SERVICE BULLETIN

APPLICABILITY: 2011-2012MY Forester Models with FB Engine **NUMBER:** 02-131-12R
SUBJECT: Oil Seepage Diagnosis and Repair Procedures **DATE:** 07/18/12
REVISED: 10/02/12

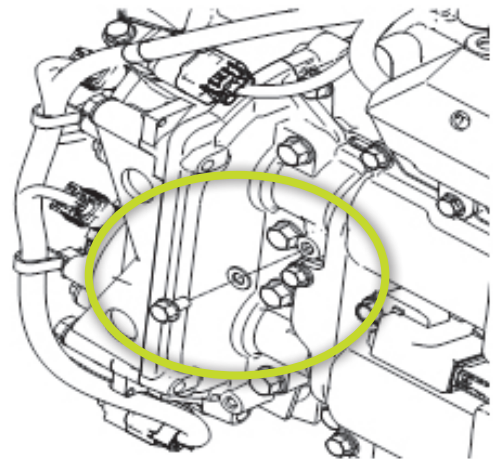
There are five areas that should be closely inspected if an oil leak is reported by the customer:

1. The 6mm tapped hole casting boss area in the left-hand camshaft cap
2. The sealing surfaces between either the left or right-hand camshaft cap and camshaft carrier
3. The sealing surfaces between the cylinder head and camshaft carrier
4. The sealing surface between the upper oil pan and the engine block
5. The sealing surfaces of the front timing chain cover

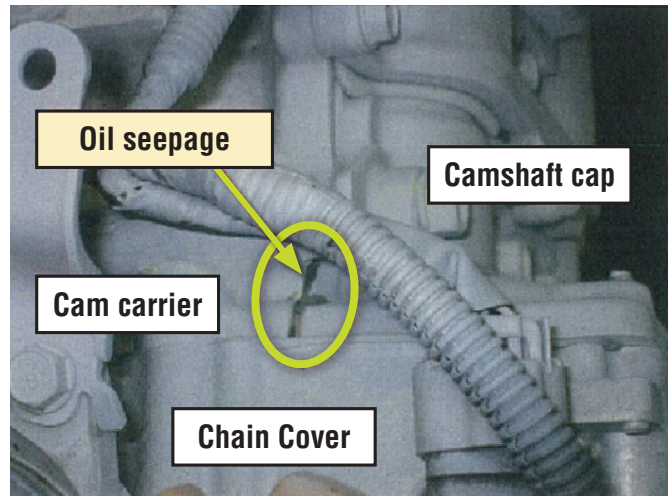
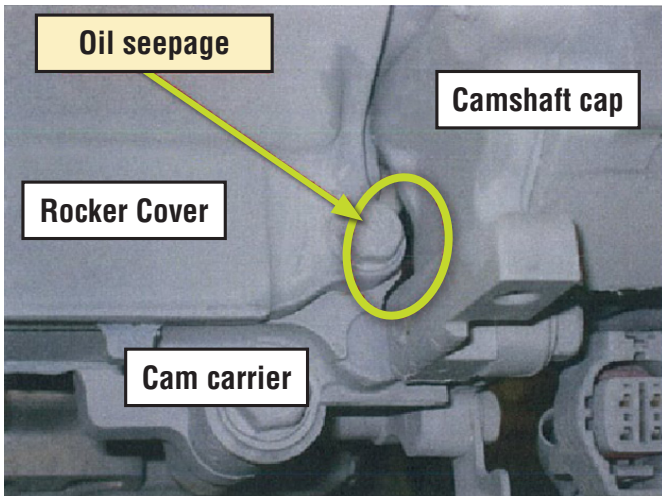
If oil seepage is verified coming from the 6mm threaded hole in the left-hand camshaft cap, install the specified bolt and flat washer.

Bolt: Part# 800206180

Washer: Part# 031106000

Tightening Torque: 6.4 +/- 0.5 Nm
(57 +/- 4 inch-pounds)

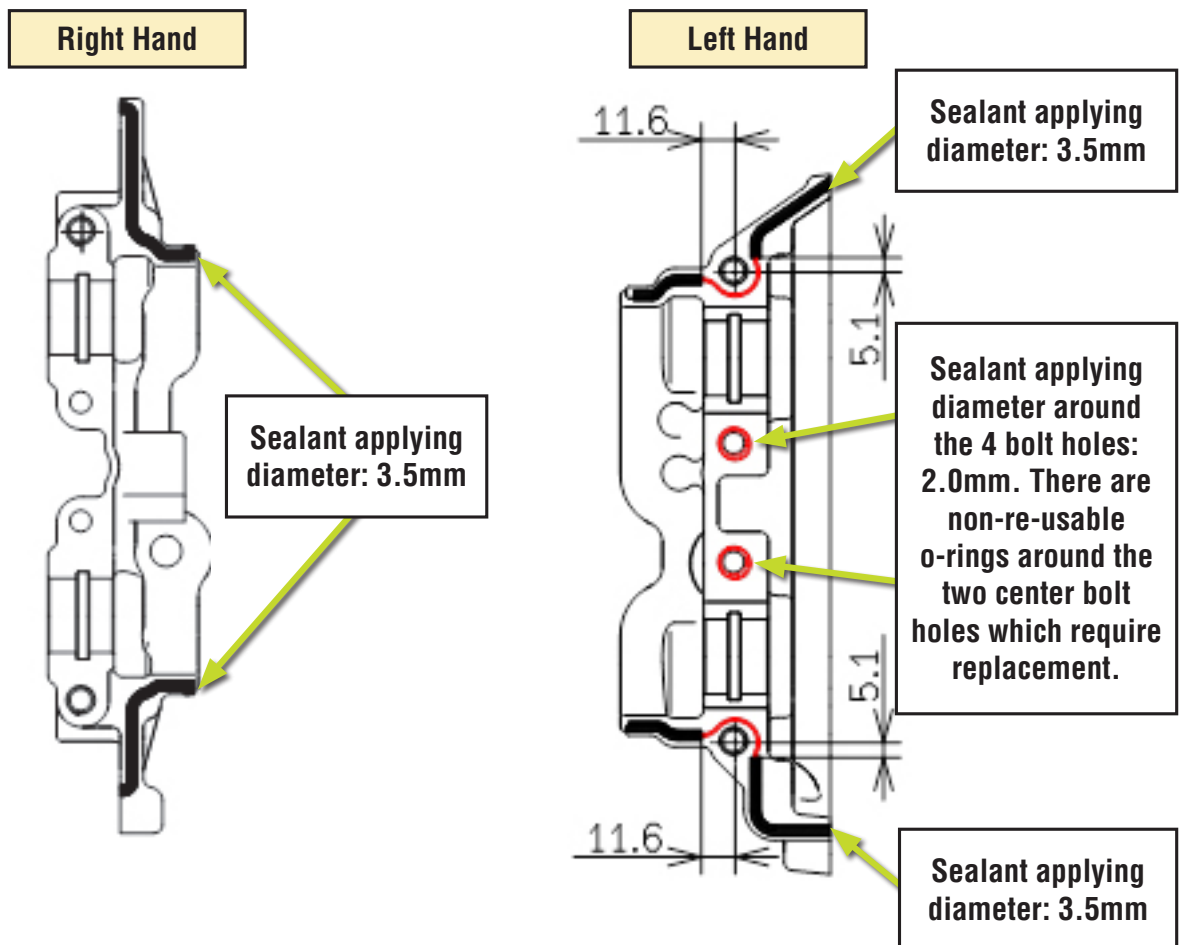
If oil seepage is verified coming from the front camshaft cap or cam carrier as shown in the photos below, remove the cam cap and clean both surfaces thoroughly before applying sealer. **Note:** The 2 o-rings between the camshaft cap and the cam carrier will need to be replaced as they are not re-usable.

Apply Liquid Gasket, ThreeBond 1280B, (Part No. SOA5499100) or equivalent* as shown below:

Cam carrier seepage seen from top left and lower right side of engine

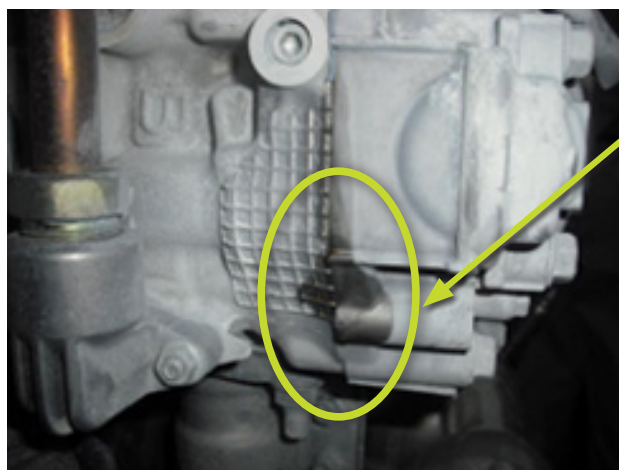
If oil seepage is verified coming from between the cam carrier and the cylinder head as shown in the photos below, remove the cam carrier. Clean the machined sealing surfaces thoroughly and then re-seal using Liquid Gasket ThreeBond 1280B, (Part No. SOA5499100) or equivalent*. As shown in the photos below, the o-rings between the cam carrier and the cylinder head will need to be replaced as they are not re-usable. This would also be a good time to clean the Active Valve Control System (AVCS) filter screens which are contained in the cam carriers. **NOTE:** The filter screens are one-time use and must be replaced if they need to be removed. The replacement filter part# is 14451AA050.

Cam carrier o-rings requiring replacement

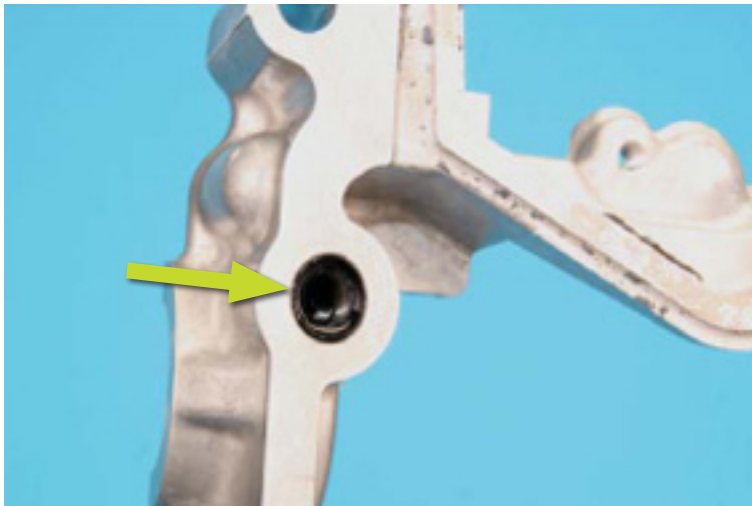
AVCS filter screen in cam carrier

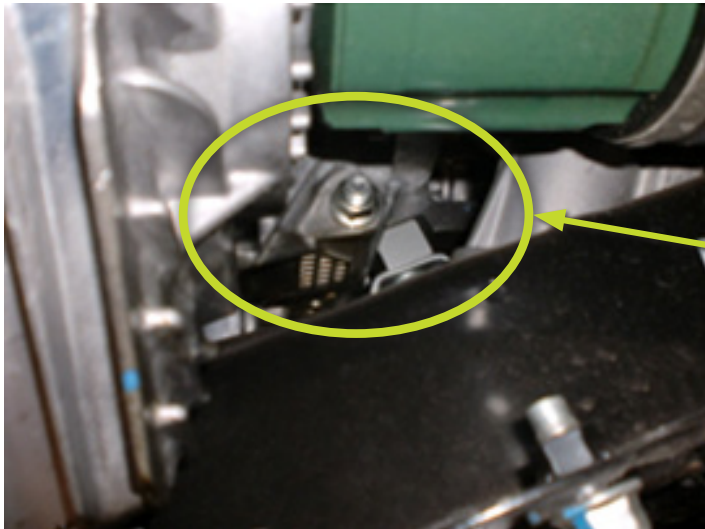
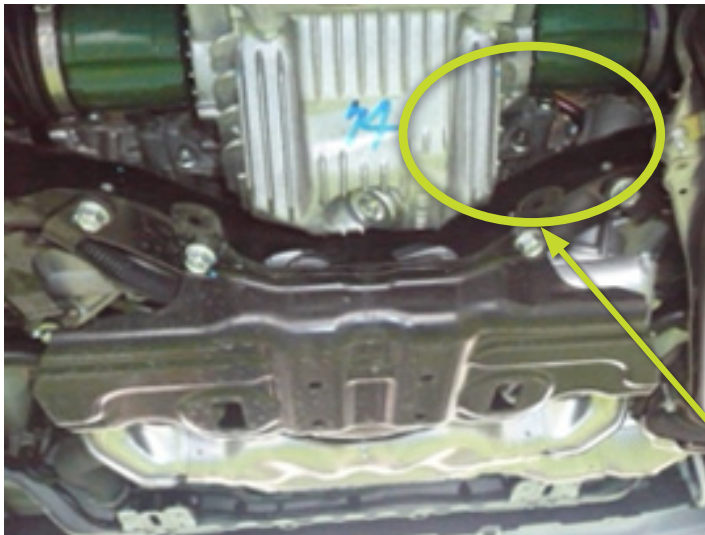
If you find engine oil seepage between the cylinder block and upper oil pan, remove the upper oil pan, clean the machined sealing surfaces thoroughly and then re-seal using Liquid Gasket ThreeBond 1280B, (Part No. SOA5499100) or equivalent*. **Note:** The o-rings between the upper oil pan and the cylinder block along with those between the upper and lower oil pan will need to be replaced as they are not re-usable.

As viewed from the rear, oil seepage from the upper pan to engine block sealing area may be present in these areas.
